# Department of ———— Environmental Protection

PERMIT/CERTIFICATION
GMS ID No: 4051M30035
Permit No: SC51-252834
Date of Issue: NOV 1 5 1994
Expiration Date: 06/01/99
County: Pasco

Materials Recovery

Facility

ELEVATION (OPTION-1)

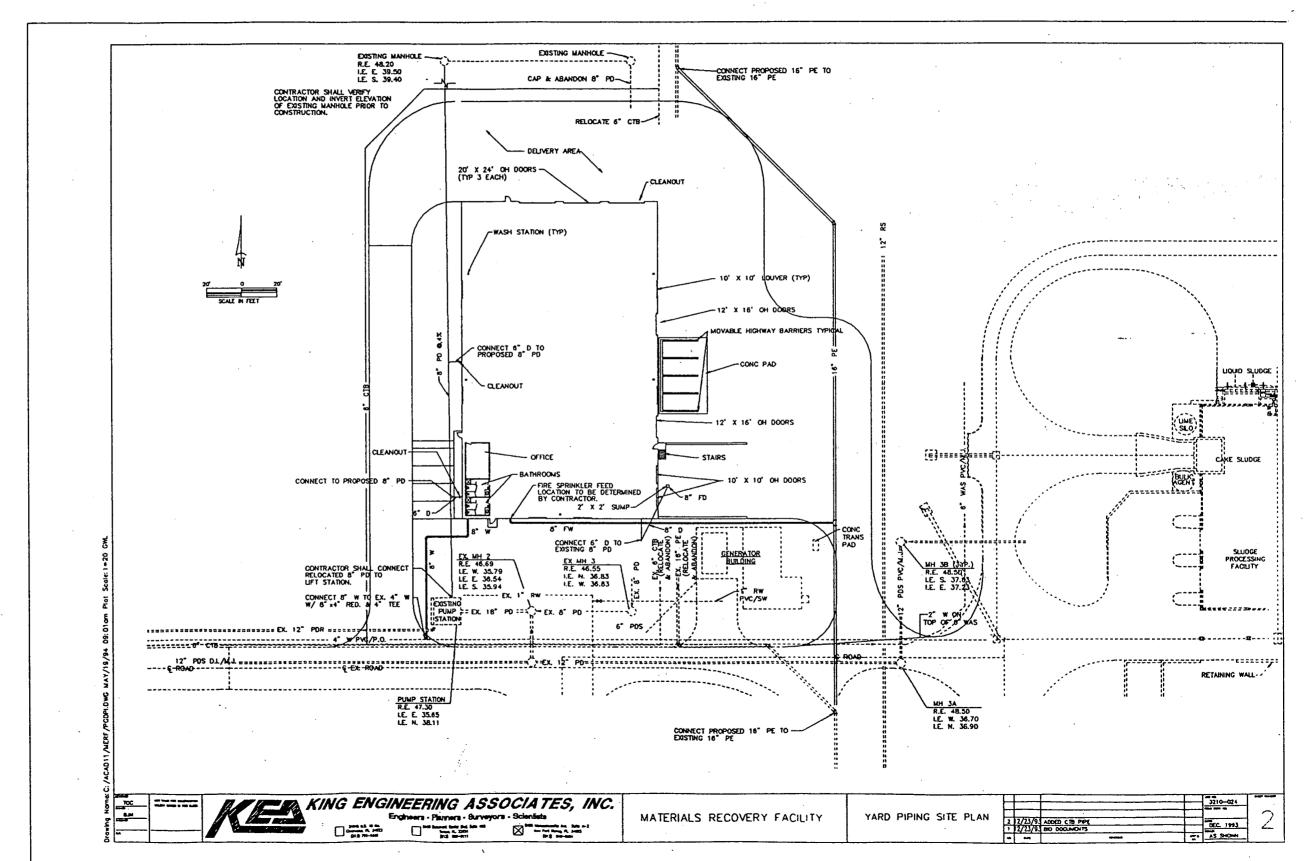
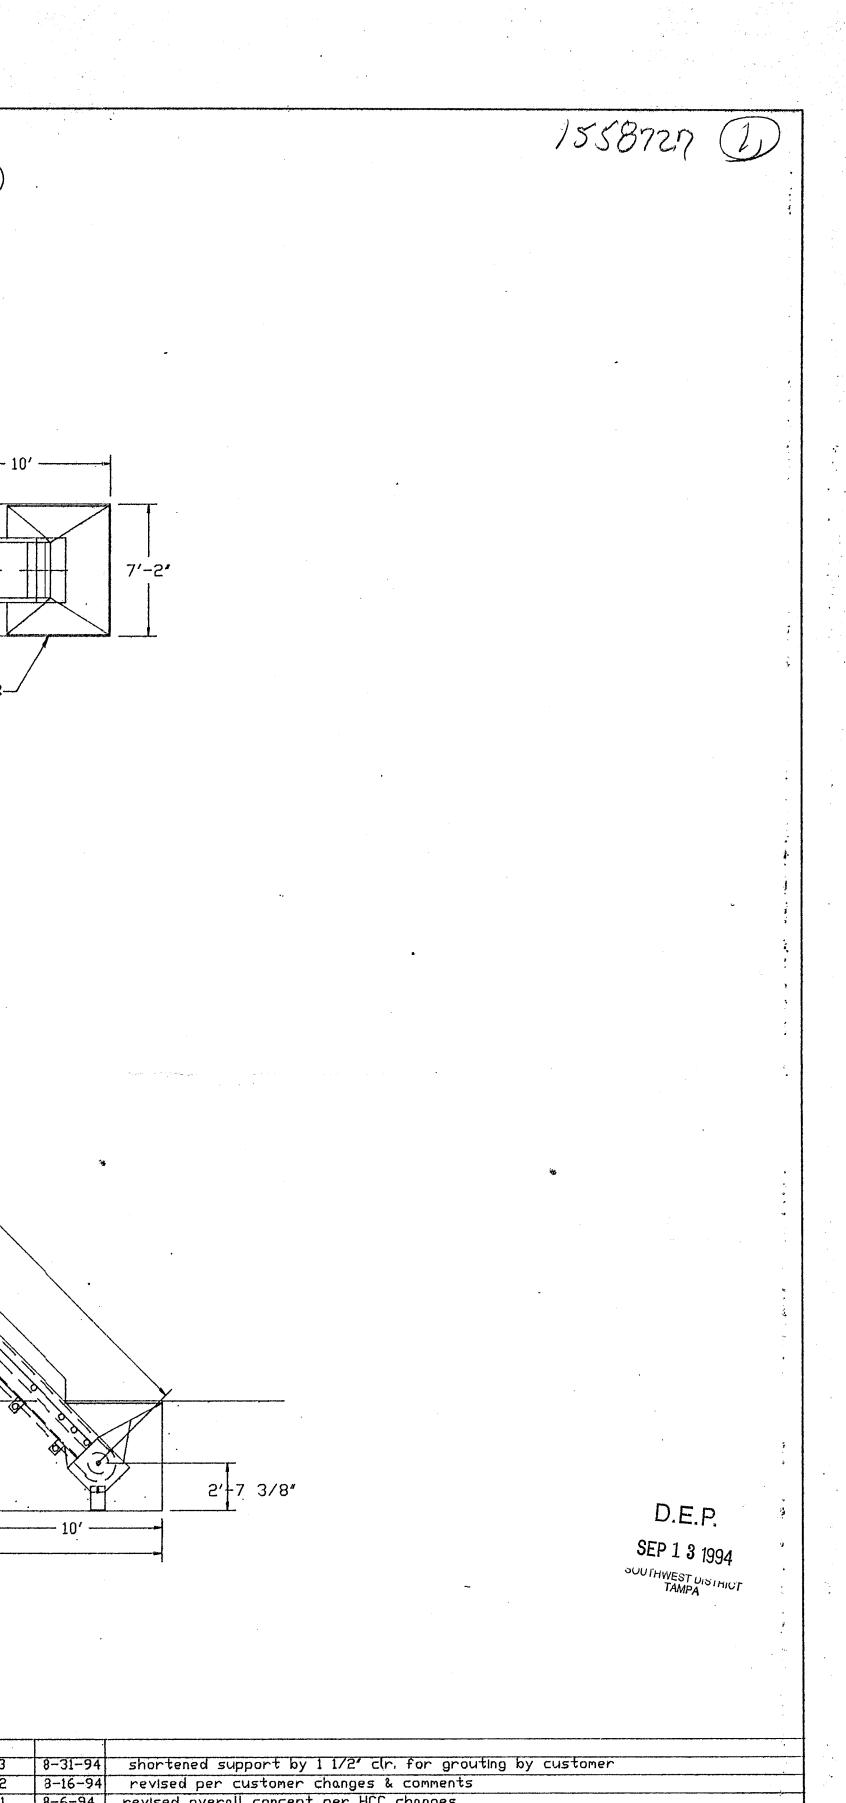
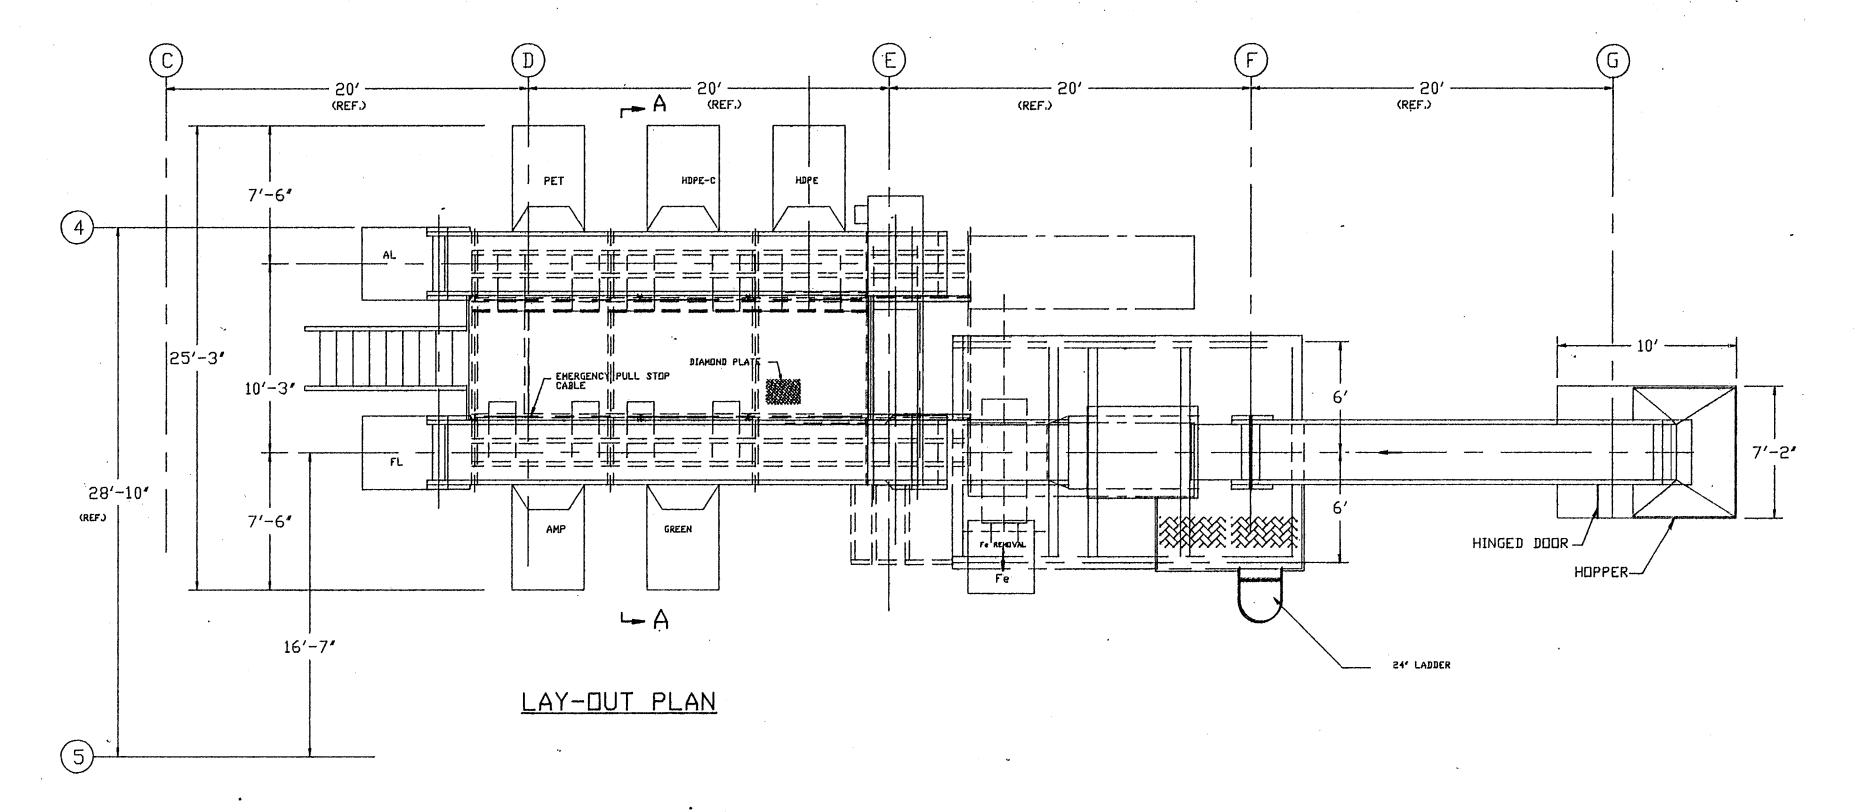
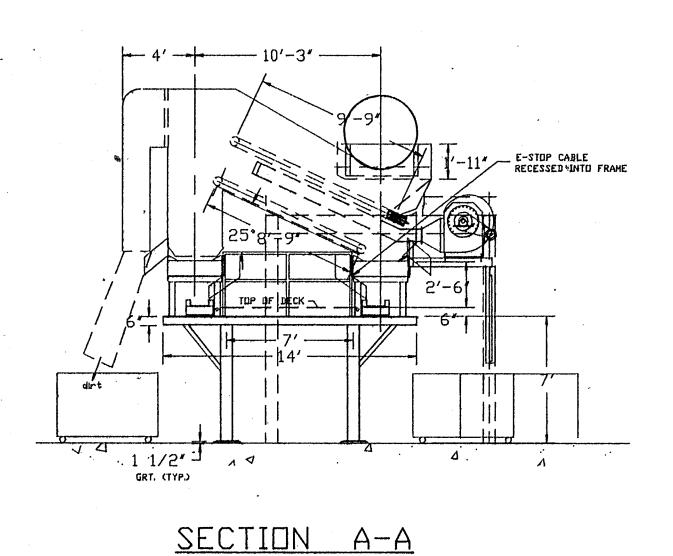
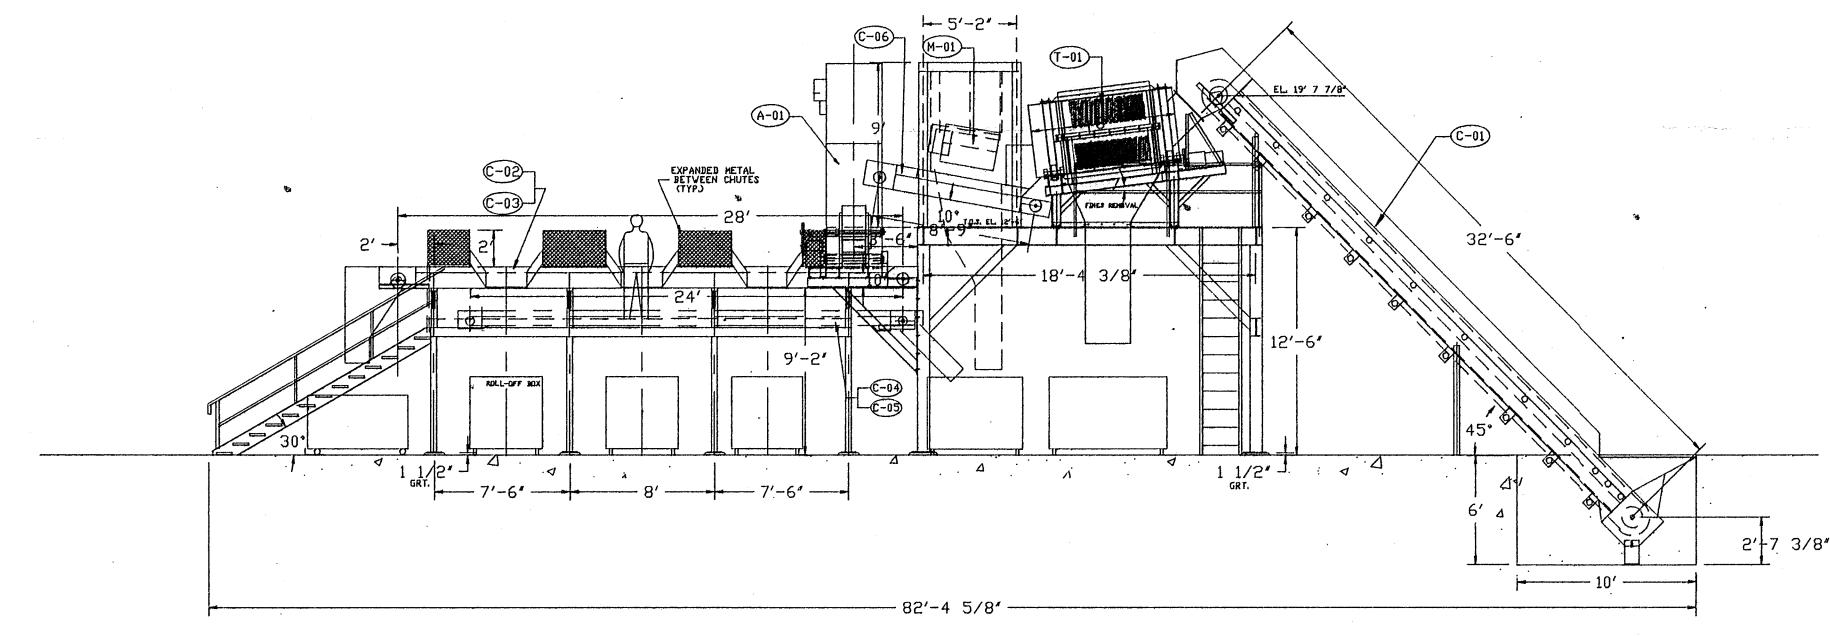
The information submitted indicates that the "sorting system [including the trommel, air classifier, and magnet] and its <u>conveyor</u> are shown on the Drawings on Sheet 3." However, the trommel, air classifier and magnet are not shown on Drawing 3. The system shown on Drawing 3 indicates a hand-sort operation only, with a single conveyor and six storage bins for separated materials. Trommels, air classifiers and magnet systems typically have two output streams, <u>each</u> with a specific associated conveyor or discharge bin. (Please revise Drawing 3 to show the trommel screen, air classifier, magnet and associated conveyor systems.)

- 1. The information submitted indicates that bags will be removed manually. Will the bags be disposed of or recycled? Is this quantity included in the residual stream of 5-10%?
- 2. The information submitted indicates that the "sorting system [including the trommel, air classifier, and magnet] and its conveyor are shown on the Drawings on Sheet 3." However, the trommel, air classifier and magnet are not shown on Drawing 3. The system shown on Drawing 3 indicates a hand-sort operation only, with a single conveyor and six storage bins for separated materials. Trommels, air classifiers and magnet systems typically have two output streams, each with a specific associated conveyor or discharge bin. Please revise Drawing 3 to show the trommel screen, air classifier, magnet and associated conveyor systems.

2. The information submitted indicates that the "sorting system [including the trommel, air classifier, and magnet] and its conveyor are shown on the Drawings on Sheet 3." However, the trommel, air classifier and magnet are not shown on Drawing 3. The system shown on Drawing 3 indicates a hand-sort operation only, with a single conveyor and six storage bins for separated materials. Trommels, air classifiers and magnet systems typically have two output streams, each with a specific associated conveyor or discharge bin. Please revise Drawing 3 to show the trommel screen, air classifier, magnet and associated conveyor systems.

Drawing #3 did not show the trommel, air classifier and magnet. The attached drawing from our equipment vendor shows these

- 2) Drawing #3 did not show the trommel, air classifier and magnet. The attached drawing from our equipment vendor shows these features. The trash conveyors are located beneath the two sorting lines and travel in a reverse direction to discharge in the trash container located under the magnet.
